RFP/SMM/51/2018 "Reconstruction works performance at the OSCE SMM premises"

Questions and answers - Batch 2

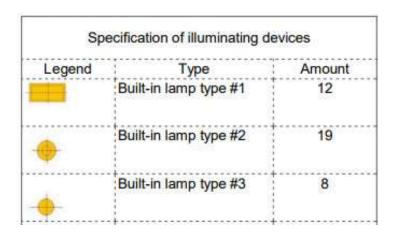
What is a desirable power capacity (W) of all kinds of luminaires in all rooms?

Answer: It is necessary to use LED lamps of capacity sufficient to meet the standards. See the table below.

Size	Qty	light flow	capacity	misc
Type 1	595*595 (for Armstong)	12	3200-3500 lm	28-32 W	
Type 2	d. 150-180 mm	19	900-1300 lm	8-16 W	
Type 3	d.100 -150 mm	8	650-1000 lm	8-12 W	IP 54
